PERMIT

SEWAGE DISPOSAL SYSTEM

HOWARD COUNTY HEALTH DEPARTMENT

SUBDIVISION No 6 H/4 LOT 51 ROAD 3429 Rolling View Court

INDICATE NORTH - NAME ADJOINING ROADWAY AS BASE LINE

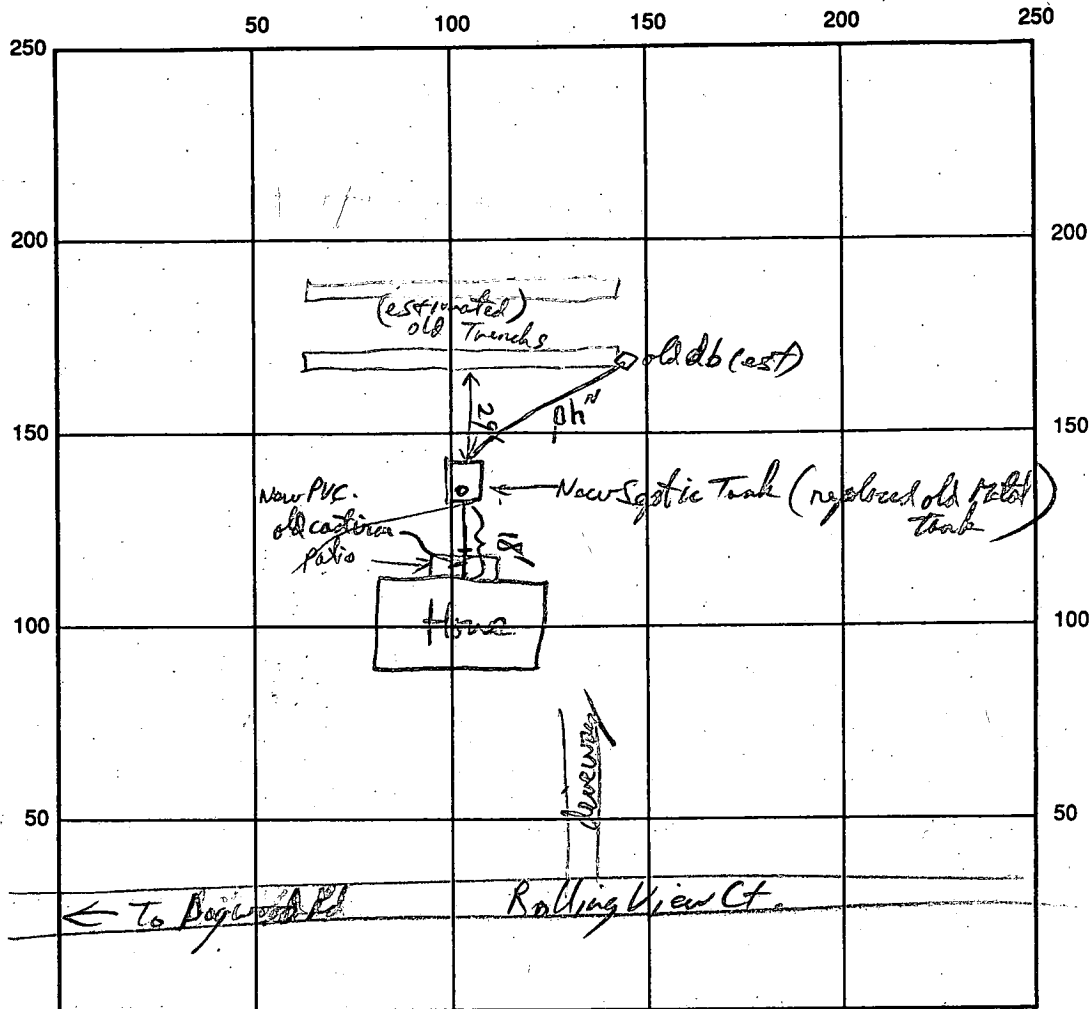
REPAIR - PURPOSE - Metal septic tank is collapsing; public sewer is available.
Call for inspection when tank is in place so that a sanitarian can approve location and size. Done 6/1/94 06/01/94

REMARKS: ST installation OK - Need to connect supply line then OK to cover - RPT 8/22/94

Septic Lines OK, Minimum Septic Tank size 1000gal. Septic Tank Replacement only
[Signature] 7/27/94
